## MEMORANDUM

**Date:** ~~April 25, 2024~~ November 19, 2024 March 14, 2025  
**To:** Aditya Jatar, BOE  
**CC:** Kaylie Coleman, Bryan Golden,  
Transportation and Public Works Department  
**Reference:** **200 E Riverside PUD Traffic Impact Analysis** (C814-2023-0057) – 200 E Riverside Dr,  
Austin, Final Memo

Figure 2. Improvement Extent

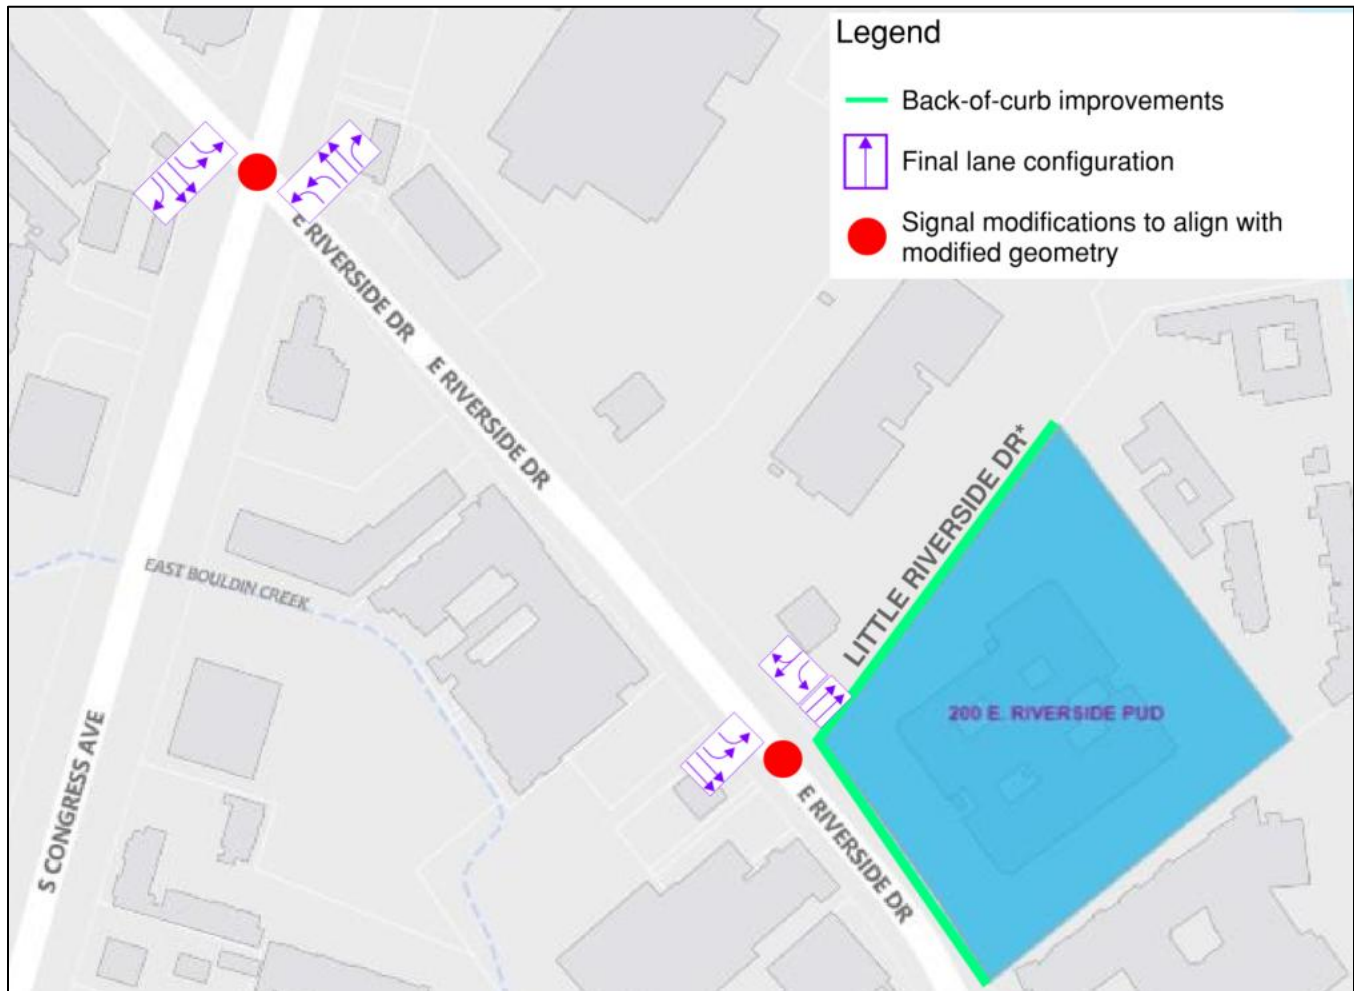
<p><i>Table 2. Improvements Identified in the TIA</i> (This will be reevaluated at the time of the site plan when more information about the site and Project Connect is available.)</p>	
Name	Improvement
E Riverside Dr & Little Riverside Dr* (See Figure 2 for the improvement extent)	Restripe existing pavement to 1L, 1 TR along SB Little Riverside Dr* approach to accommodate SB LTL on Little Riverside Dr*
	Provide 1 additional LTL to create dual left turn lanes along EB approach
	Widen NB approach with merge taper along Little Riverside Dr* to provide additional receiving lane for EB to NB dual left turns
	Signal re-timing, lane assignment sign, signal head modification as needed to align with modified geometry
E Riverside Dr & S Congress Ave (See Figure 2 for the improvement extent)	Install 1 additional LTL to create dual left turn lanes along EB E Riverside Dr approach
	Install 1 additional LTL to create dual left turn lanes along WB E Riverside Dr approach

Install 1 RTL along WB E Riverside Dr approach
	Signal re-timing, lane assignment sign, signal head modification as needed to align with modified geometry
Back-of-curb Improvements (See Figure 2 for the improvement extent)	Design and construct back-of-curb improvements with the coordination of TPW along site frontages on Little Riverside Dr* & E Riverside Dr
